| Model: Model PL-P1 | | Date: 30-Apr-04 | No.: MG108001 |
| Modified Article: Parts Catalog Correction | | Prepared by: H.Taguchi | |
| From: 1st Tech. Support Sec. Service Support Dept. | | | |

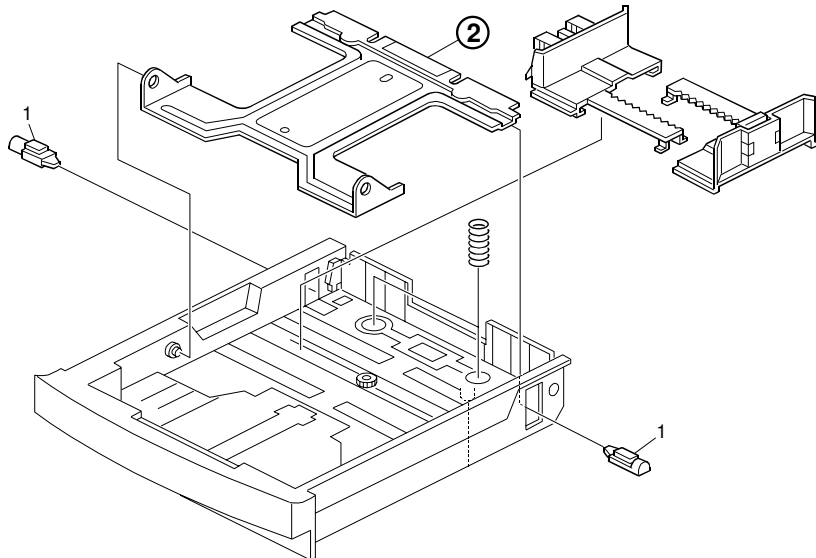
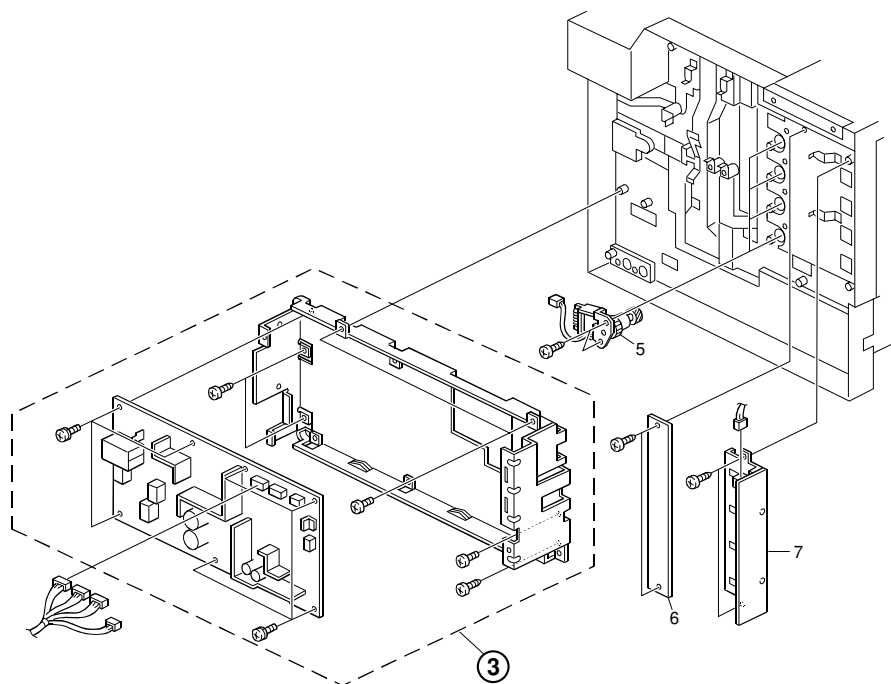
The illustration has been changed as follows.

Page 4: Index 2 has been revised.

Page 20: Index 3 has been revised and Index 8 has been deleted.

- Page2: Index 12 has been revised.

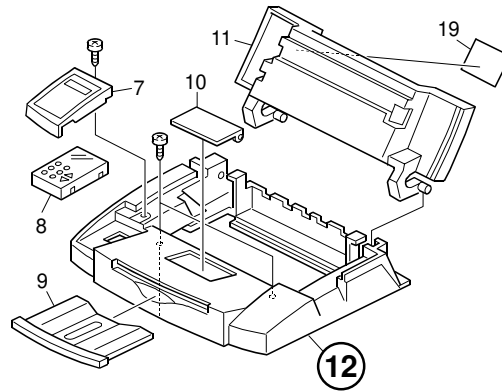
Please apply the following illustration corrections to your Parts Catalogs:

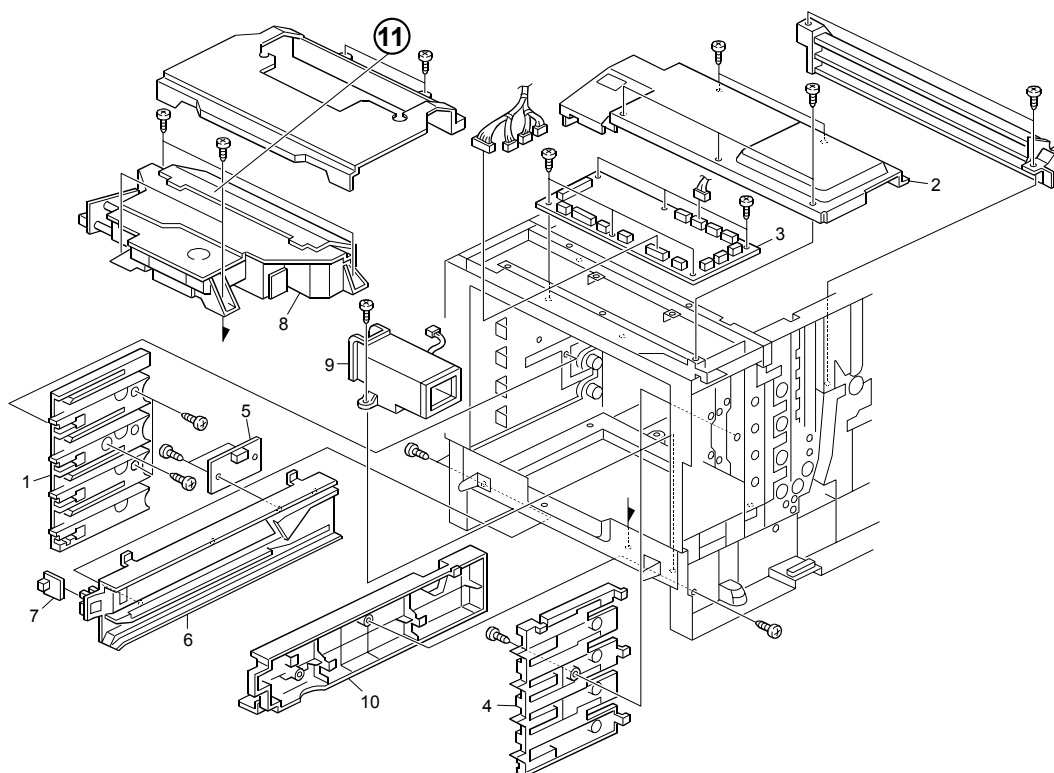
The dust proof cover is newly registered as a service part.

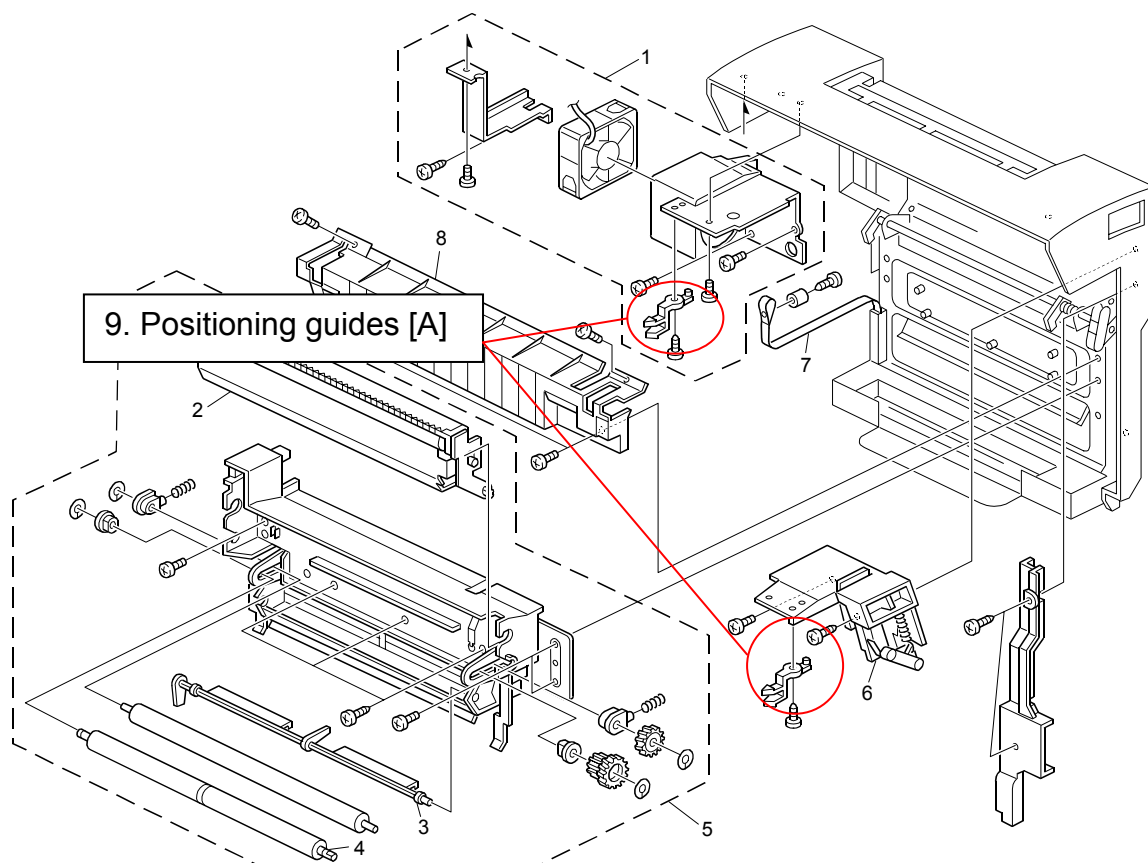
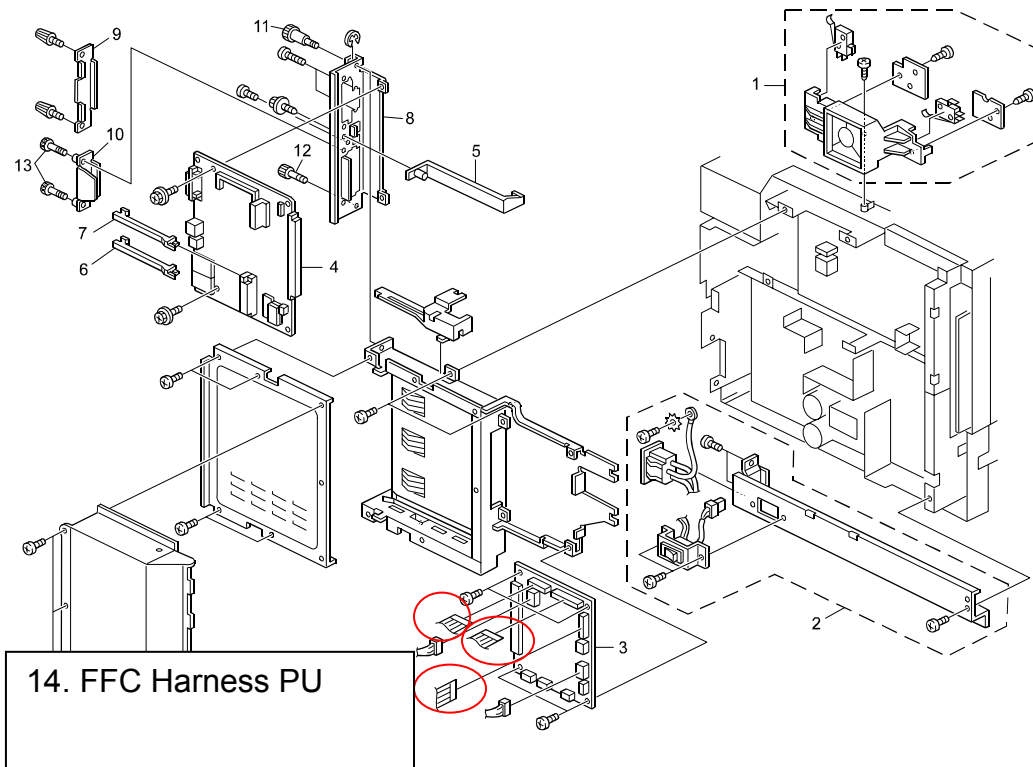
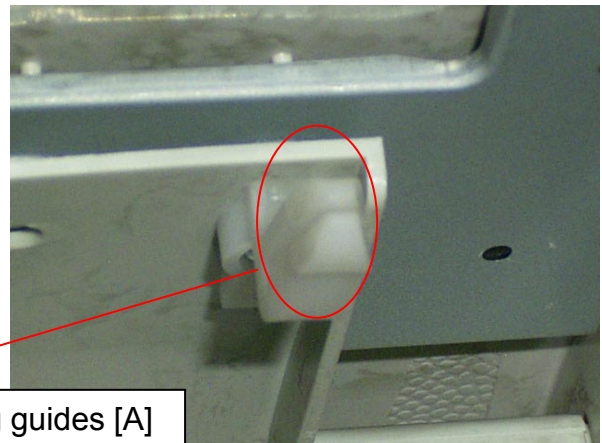
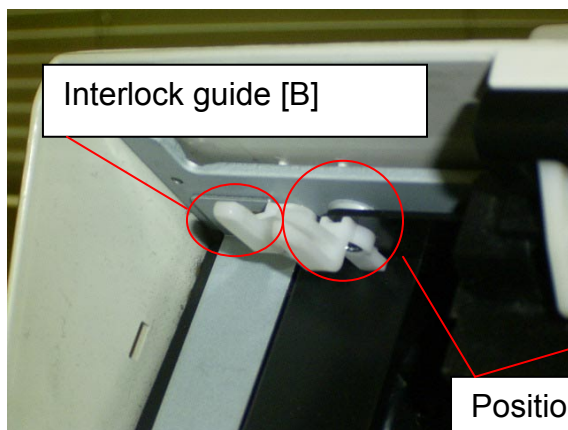
Change: The parts in the table were newly registered.

Reason: A request was received from the field.

- The PP5 Guide Set includes two positioning guides [A] and one interlock guide [B].
- The FFC Harness PU includes three harness cables.

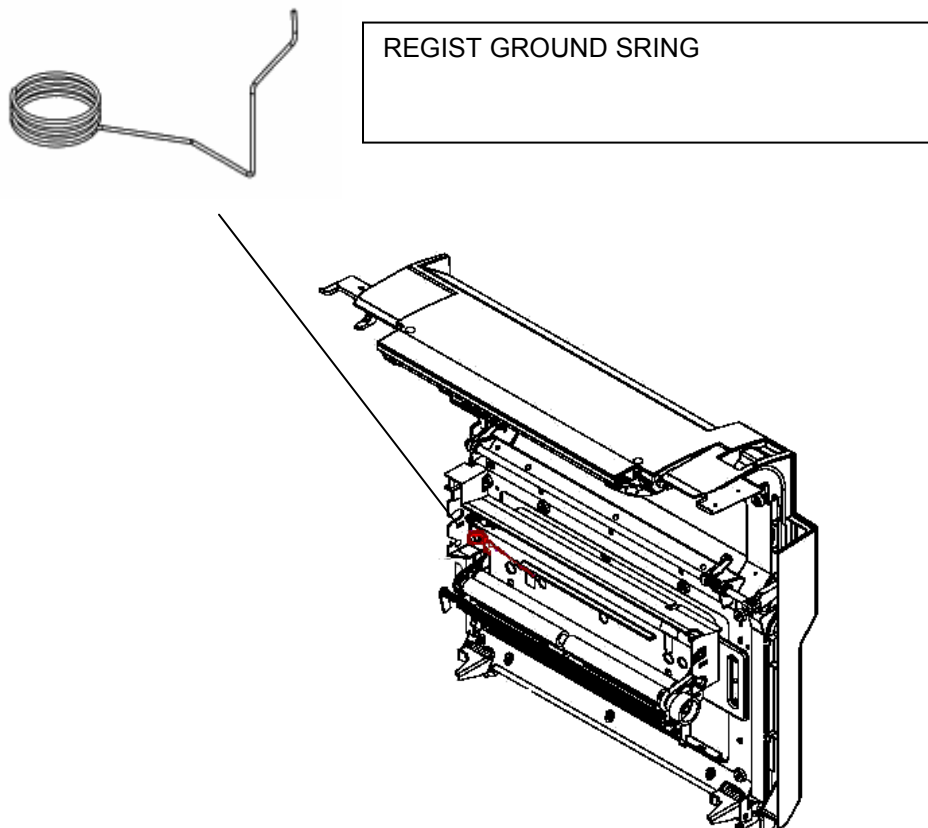
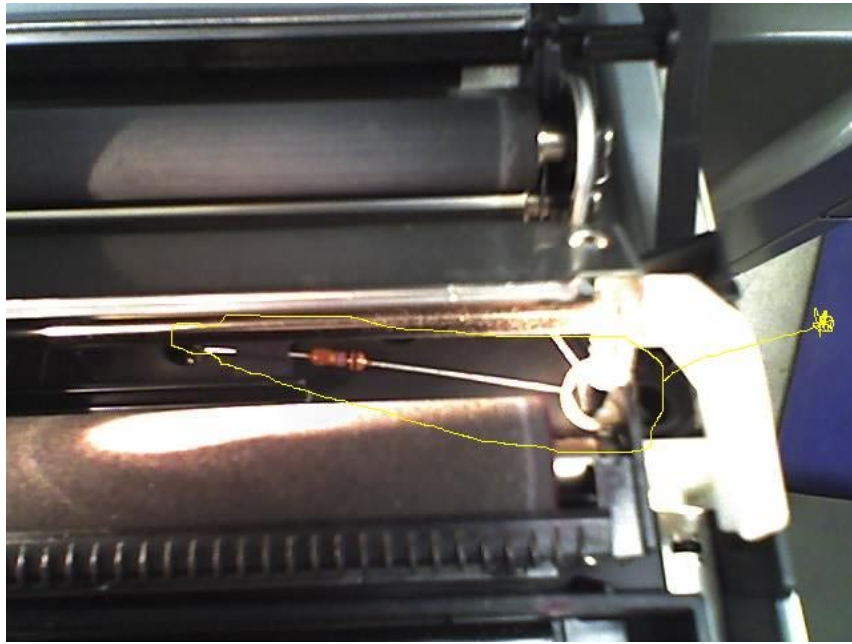
Change: The part in the table was added.

Reason: Requests were received from the field.

Important: Handle this spring carefully. Make sure not to deform or bend the spring, as this can cause jams, noise, or poor image transfer.

On page 2
23 SL5F LOCK LEVER
ASS'Y (Metal & Plastic
parts)

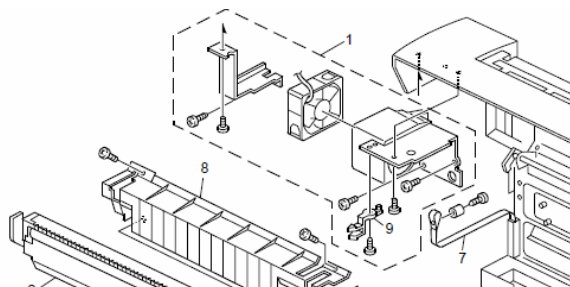
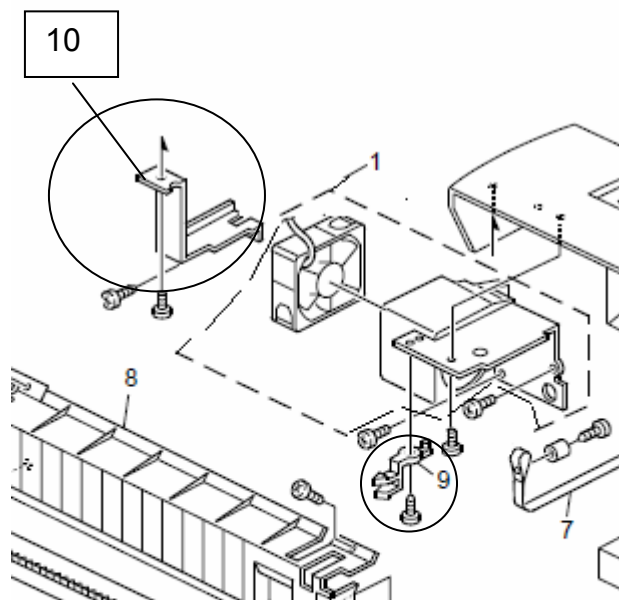
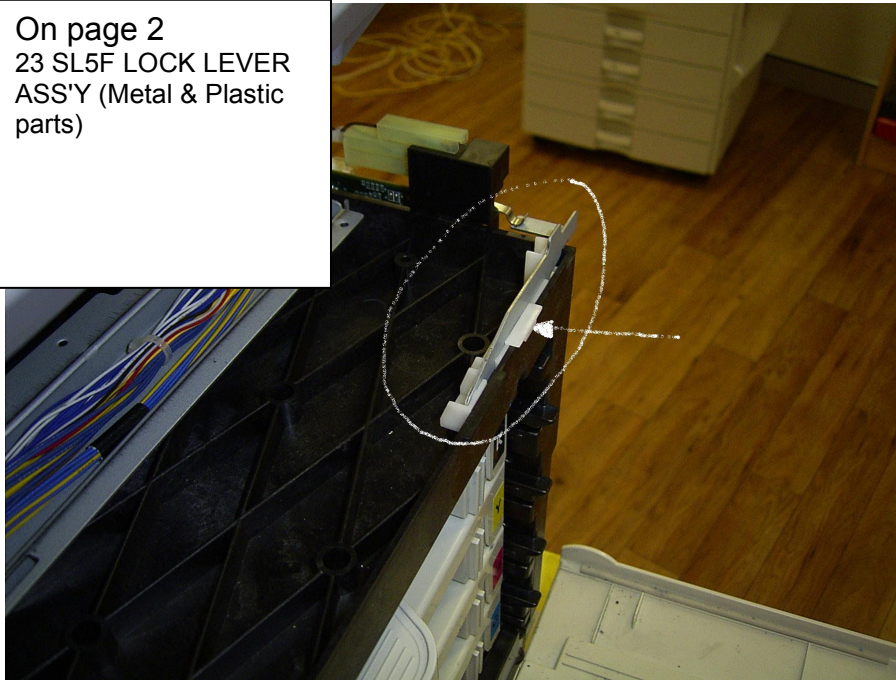
- 1) The parts in the table were missing from the Parts Catalog.
- 2) The illustration below was corrected (index #10 and circled areas were added).

Incorrect

Correct

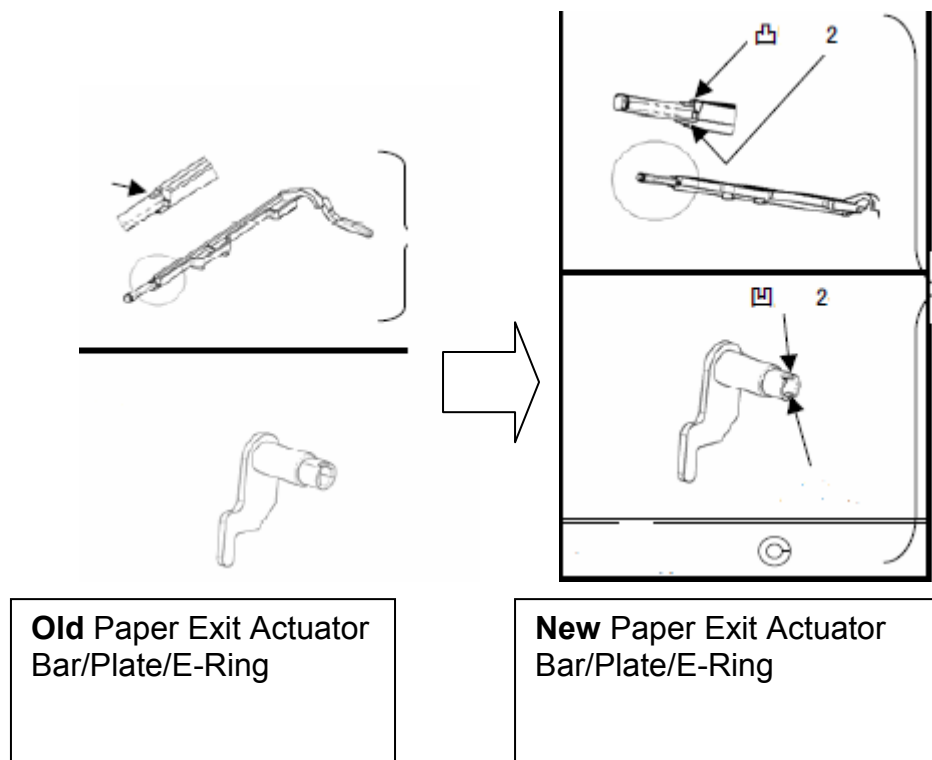
- 1) The shapes of the paper exit actuator (V128497) and bar (not a service part) were changed.
- 2) The new actuator and new bar were combined into one service part (V128720).

Reason: To facilitate assembly.

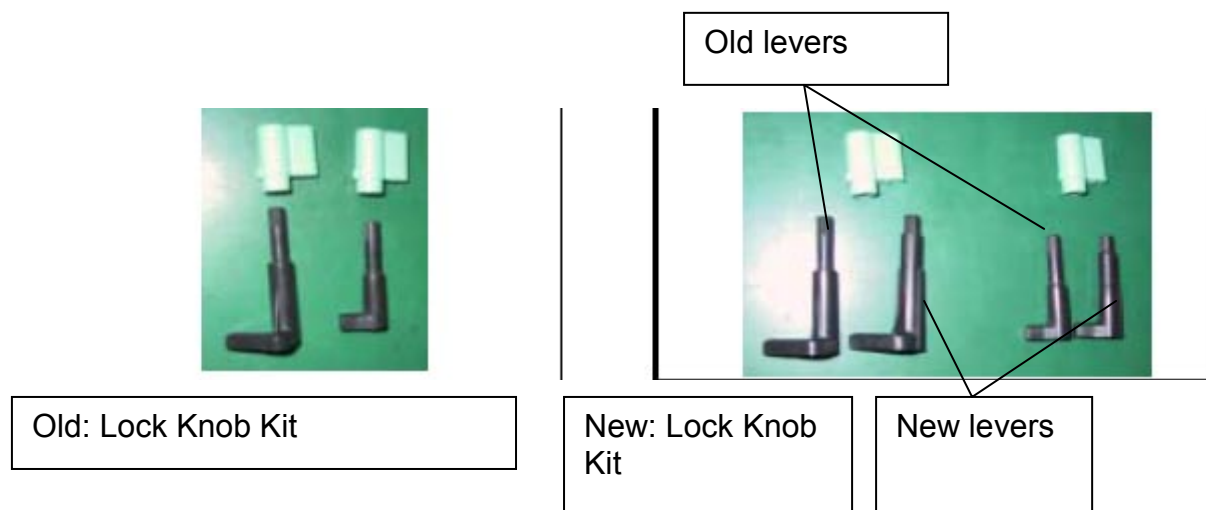
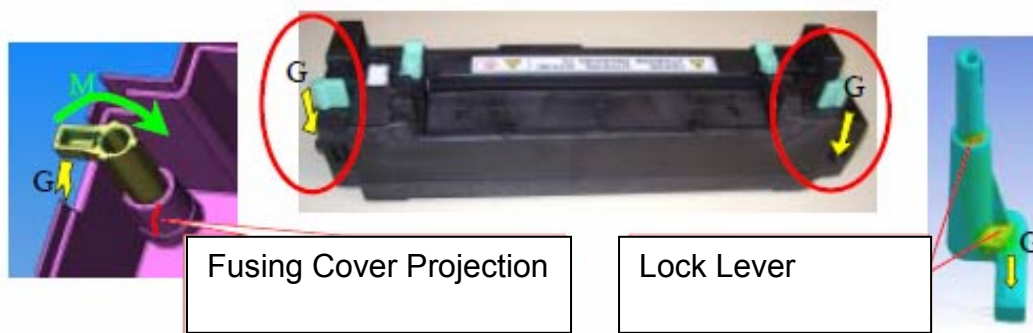
Change: The shapes of the fusing cover projection and lock lever were changed.

Reason: To increase the durability of these parts.

Important: If the old top fuser cover needs to be replaced, install the new top fuser cover **together with** the new lock levers in the new lock knob kit.

| New | <p>Ribs added</p> | <p>Shape changed</p> <p>A</p> <p>B</p> <p>C</p> |

A: Shape changed
B: Rib added
C: Rib extended

Note: The new lock knob kit contains both the old and new lock levers, so that you can replace the lock knob.

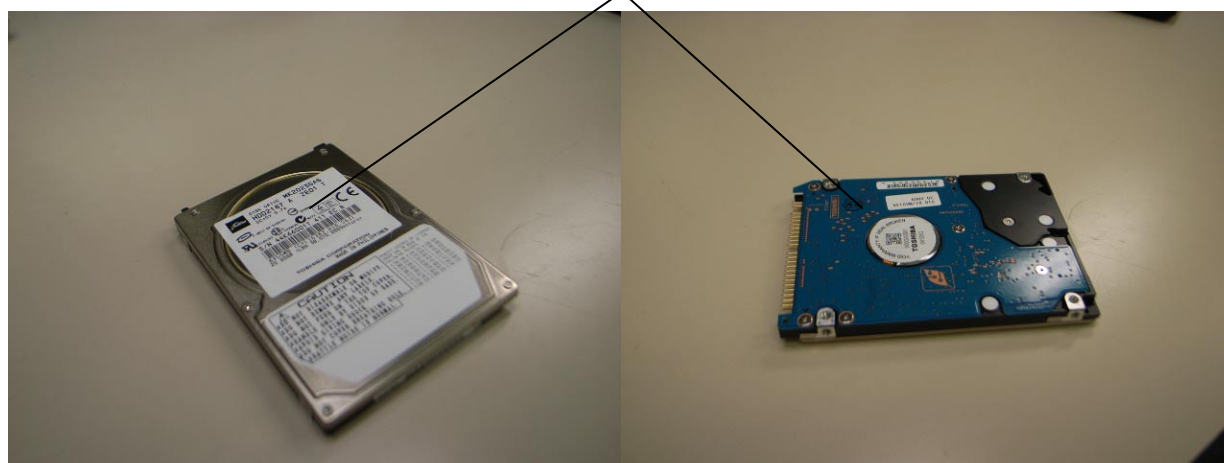
Change/Reason: Vendor change (to a Fujitsu-made HDD). The old part number was missing from the Parts Catalog.
